Alexander Schleicher - Segelflugzeugbau - Poppenhausen/Wasserk.

Modification No. 8
Glider Ka 2 a. Ka 2 B
L - 140 a. L - 203

(US 7G3)

Check of stick attachment in the rear cockpit.

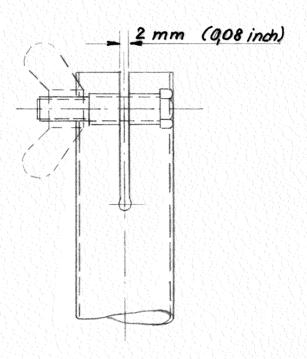
Probable by deformation on the tube nozzles there has been found a loose stick although the wing nut was fastened.

- 1) Check if the both tube nozzles are not bended by the screw so that it is possible to pull out the stick even when the wing nut ist fastened.
- 2) Check the gap for the wide of 2 mm (0,08 inch). If neccessary make it wider by a file. (See scetch). With fastened wing nut, the stick must be reliablely fixed.
